Bill No. 01R-74

FACTSHEET

TITLE: SPECIAL PERMIT NO. 1881, EAGLE VIEW COMMUNITY UNIT PLAN, requested by Brian D. Carstens and Associates on behalf of Hoegemeyer-Palmer Construction, for 12 dwelling units on property generally located at Peregrine Court and Talon Road.

**SPECIAL PERMIT NO. 1881
EAGLE VIEW COMMUNITY UNIT PLAN
and
PRELIMINARY PLAT NO. 00026,
EAGLE VIEW**

COMMUNITY UNIT**LEGAL DESCRIPTION:**

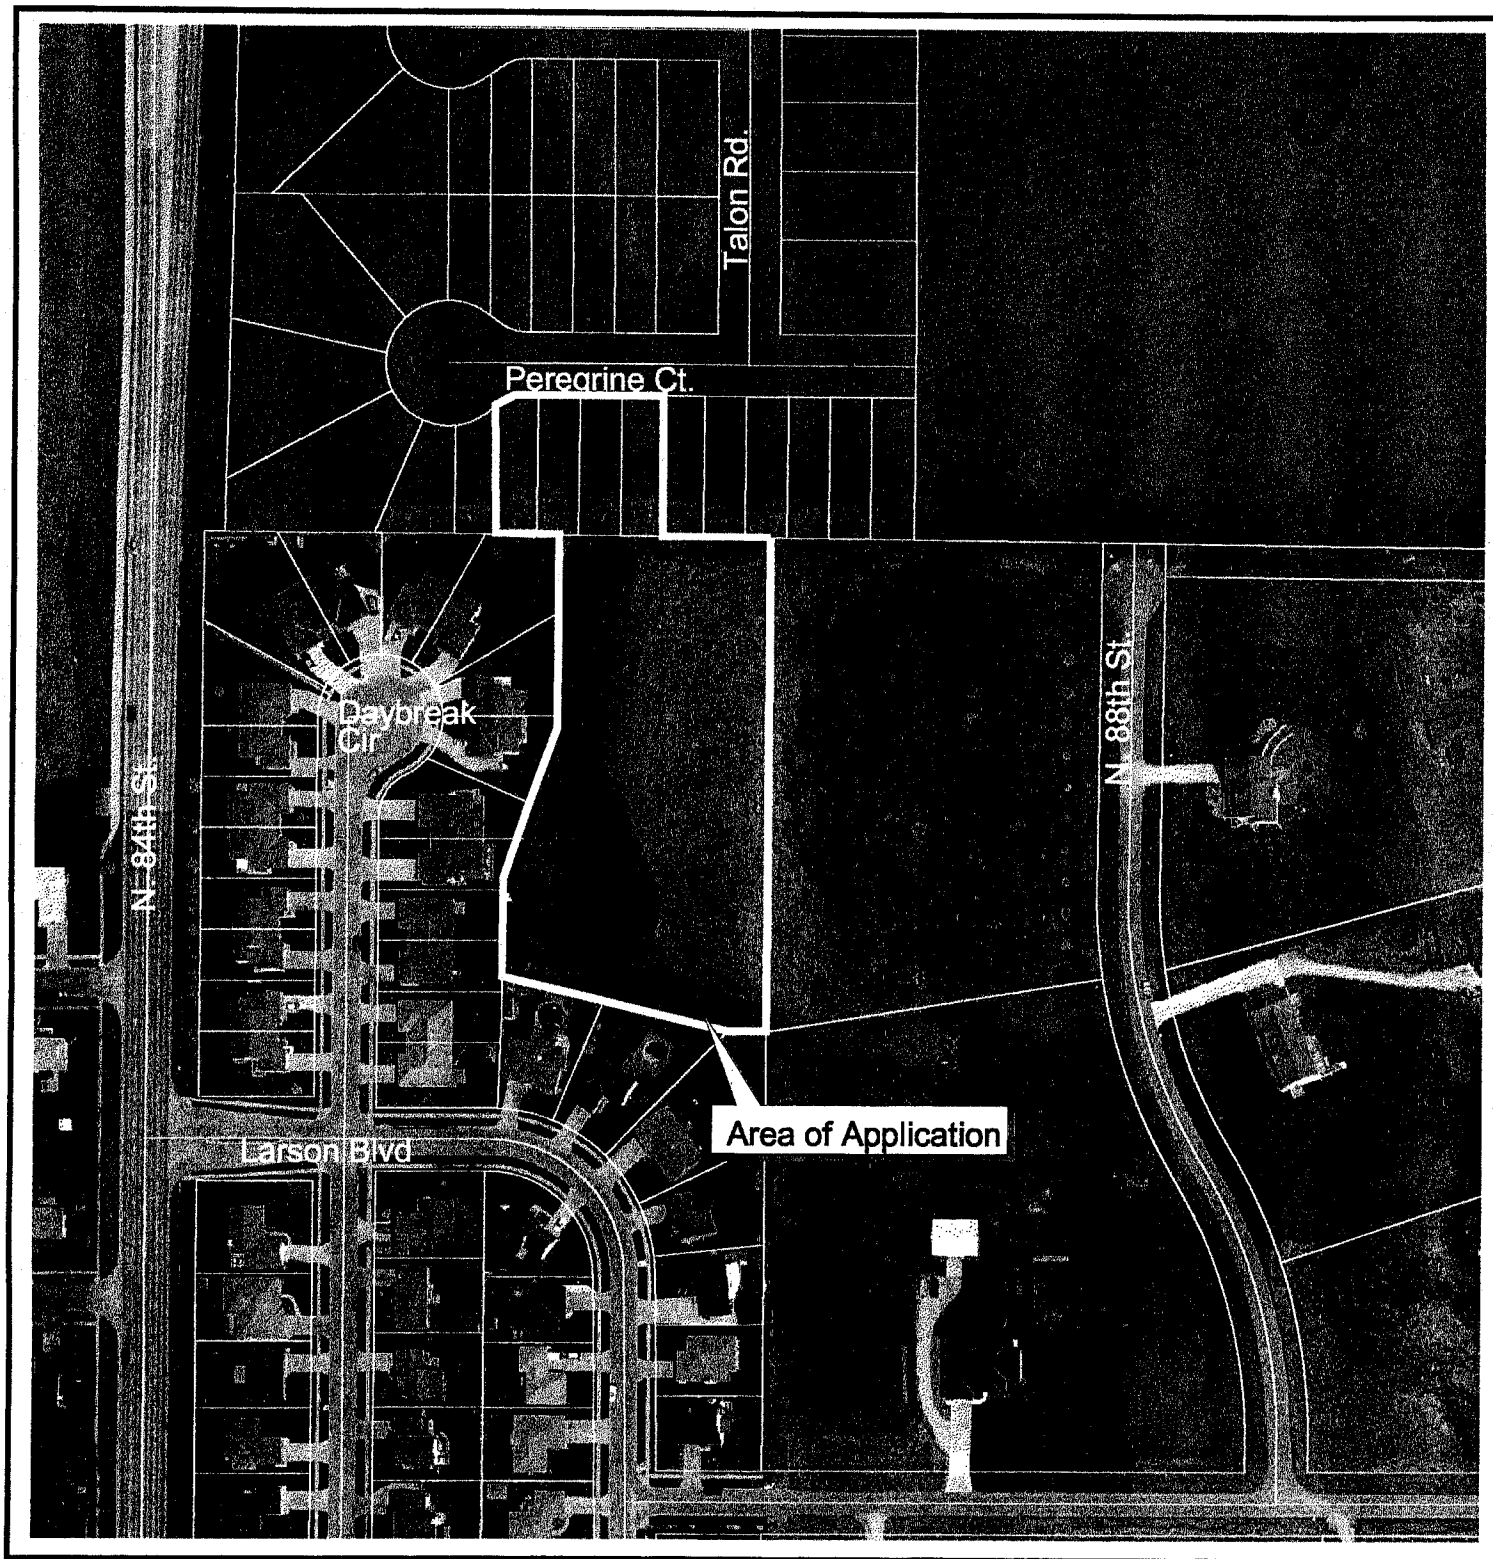
The proposed water system needs revision. A looped water system is required to provide design standard water flows.

5. The Public Works Department noted that “the water system still requires further revision. A 16" water main is anticipated to be needed along the west side of 86th. This plat shows a 8" main on the east side and connecting the water system in Peregrine Court to a main in 84th Street. The main in 84th required to provide the looped water system to provide design standard water flows must be looped to the 16" water main rather than building a second main in 84th Street. The calculations submitted show that even with an 8" main in Eagle View Court, the water design standards cannot be met without a water main loop.”

7. The area specified in the legal description of the Preliminary Plat needs to be revised to reflect the correct area.
8. The street trees on Lots 1 and 2 on Peregrine Court need to be spaced 40' apart.

1.1.1 A looped water system to the satisfaction of Public Works

1.1.5 Revise the street trees on Lots 1 and 2 to be 40' apart.
